QUESTIONS AND ANSWERS (Q & A), [2]

RFP/2016/771, FOR THE PROVISION OF FIELD MAINTENANCE AND REPAIR OF UNHCR MOTORIZED ASSETS

QUESTIONS AND ANSWERS (Q & A)

RFP/2016/771, FOR THE PROVISION OF FIELD MAINTENANCE AND REPAIR OF UNHCR MOTORIZED ASSETS

“KPIs” for Fleet Management Performance (called dashboard)

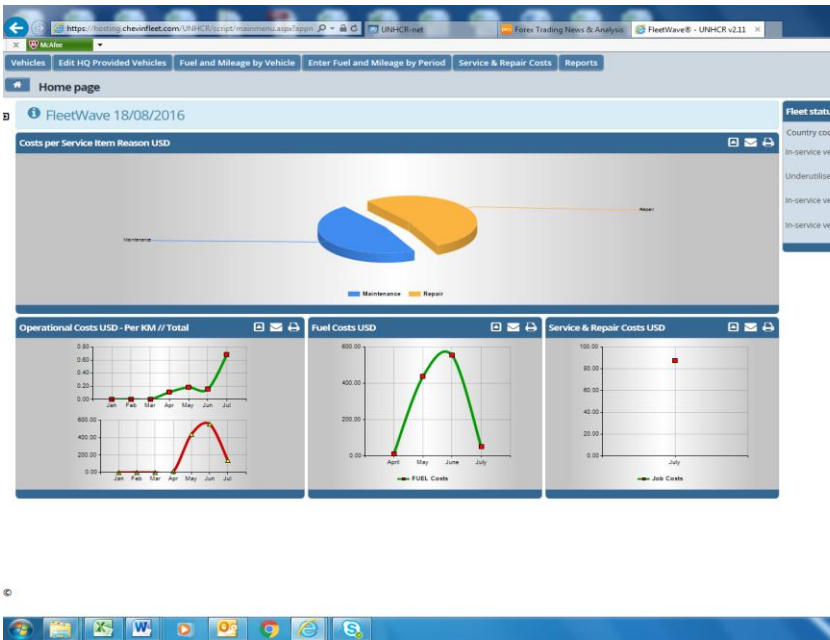
30	Annex A - TOR. 1.3.1 Improve utilization and availability of UNHCR vehicles, p. 5. What is the current vehicle/fleet availability and can this be broken down by country?	UNHCR does not have this information, however the goal is to have visibility on fleet availability. For more information please refer to TOR 5.1 Key Performance Indicators and Service Level Agreement.
31	Annex A TOR Annex 6, p 48: B service B service schedule includes the checking of the "fuel injection pressure and state of the nozzle spraying patterns" and "calibration of the injector pump and injectors". Can UNHCR confirm that these activities are a requirement of every B service?	As discussed in the vendor conference it is not needed at every B service only when it is necessary (e.g. excessive exhaust smoke). We cannot change the UNHCR Service Book as it is an extract received from the vehicle manufacturer.
32	Bidder's Conference: During the conference, it was stated that FleetWave had KPIs listed in the platform. Can UNHCR provide those KPI's?	Please see tab for the currently existing KPIs - also called Fleetwave Dashboard.
